Planning Commission Meeting

PLANNING COMMISSION AGENDA

Development Review Committee Minutes

On October 7, 2024, plans were submitted for the Harmony Ridge Plat "G" subdivision consisting of 113 townhome lots. The items below include 1) requested changes to the submitted plans, 2) other items required as part of the application and/or 3) informational items regarding city standards.

SHEET 1 OF 2

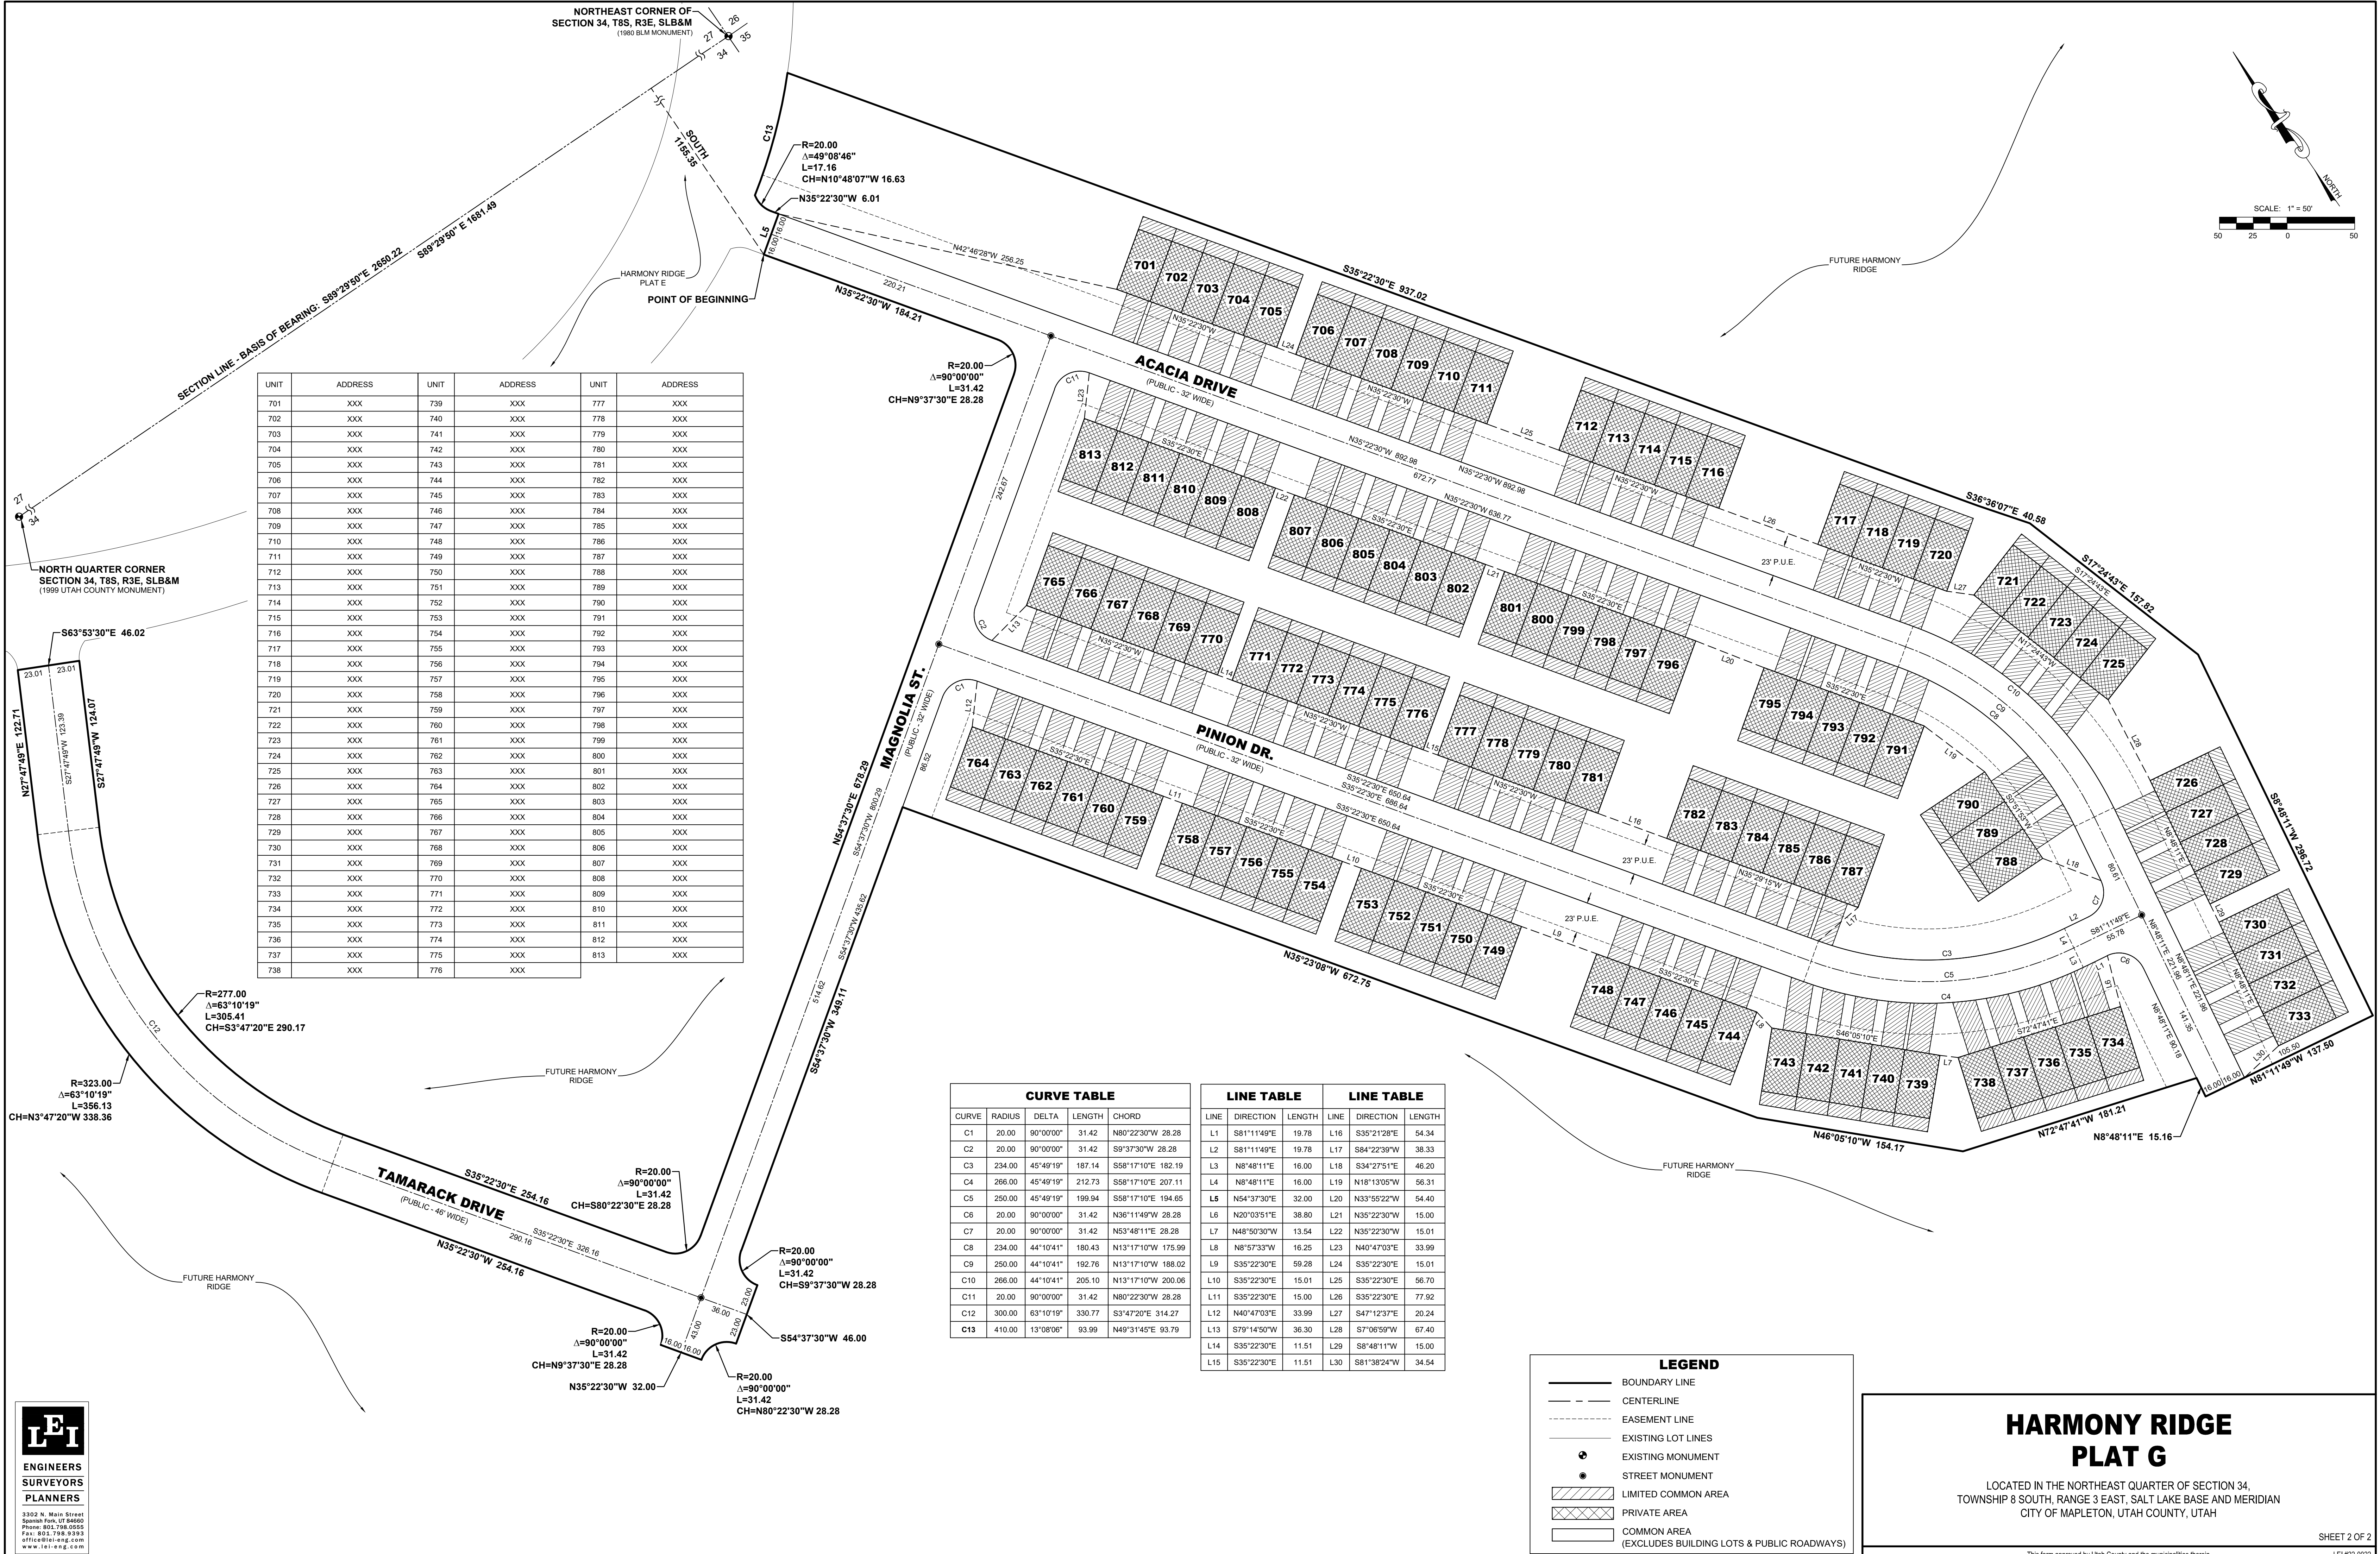
1. Please include the attached addresses on the final plat.
2. Please provide the total irrigable acreage for a determination of the outdoor water needs.
3. Once plat is recorded, Edge will record a Deed of Trust for the secured parcel as described in the development agreement.
4. The preliminary plat will require planning commission approval.
